Access Compliance Report

Public Rights-of-Way

Intersection ID: 10019201	Main Street: WINTERFIELD_PL	Cross Street: N/A	Location: W
ADA ID: 6EA44193967E	Ramp Type: Perp	Initial Pass/Fail: Fail	Overall Compliance: No
		Severity Score: 25

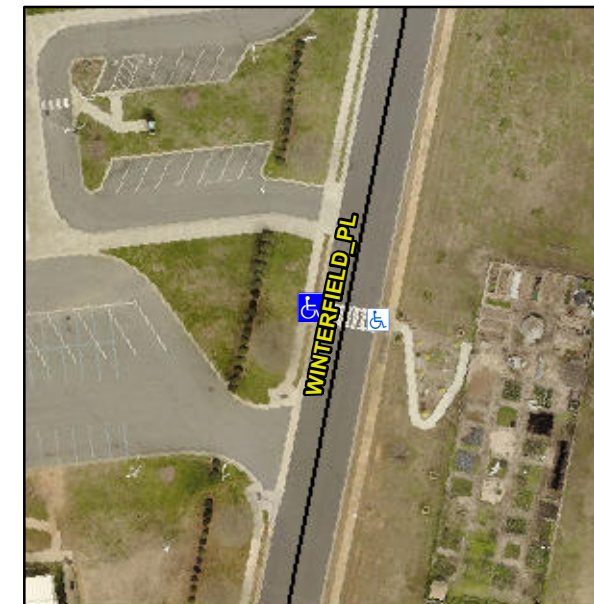
Not Found, R304.2.2

Compliance	Description	Data	Compliance	Description	Data
N/A	Ramp Length (in)	31.5	No	Ramp Slope (%)	13.2
Yes	Ramp Width (in)	48.0	Yes	Ramp XSlope (%)	0.4
N/A	Flare Type LT	N/A	N/A	Flare Type RT	N/A
N/A	Flare Slope LT (%)	N/A	N/A	Flare Slope RT (%)	N/A
N/A	Flare Traversable LT?	N/A	N/A	Flare Traversable RT?	N/A
N/A	Landing Length (in)	N/A	N/A	DWS Provided?	N/A
N/A	Landing Width (in)	N/A	N/A	DWS Contrast?	N/A
N/A	Landing Slope (%)	N/A	N/A	DWS Length (in)	N/A
N/A	Landing X Slope (%)	N/A	N/A	DWS Full Width?	N/A
N/A	Landing Curb? (Y/N)	N/A	N/A	DWS Offset (in)	N/A
N/A	Shared Landing?	N/A			
N/A	Gutter Ponding?	N/A	N/A	Gutter Slope (%)	N/A
N/A	Gutter Lip Ht (in)	N/A	N/A	Gutter X Slope (%)	N/A
N/A	Painted X Walk1?	Yes	N/A	Painted X Walk2?	N/A
	X Walk 1 Direction	To E		X Walk 2 Direction	N/A
N/A	X Walk 1 Width (in)	112.0	N/A	X Walk 2 Width (in)	N/A
	X Walk 1 Slope (%)	6.4		X Walk 2 Slope (%)	N/A
	X Walk 1 X Slope (%)	0.9		X Walk 2 X Slope (%)	N/A

Remove & Replace Entire Ramp.
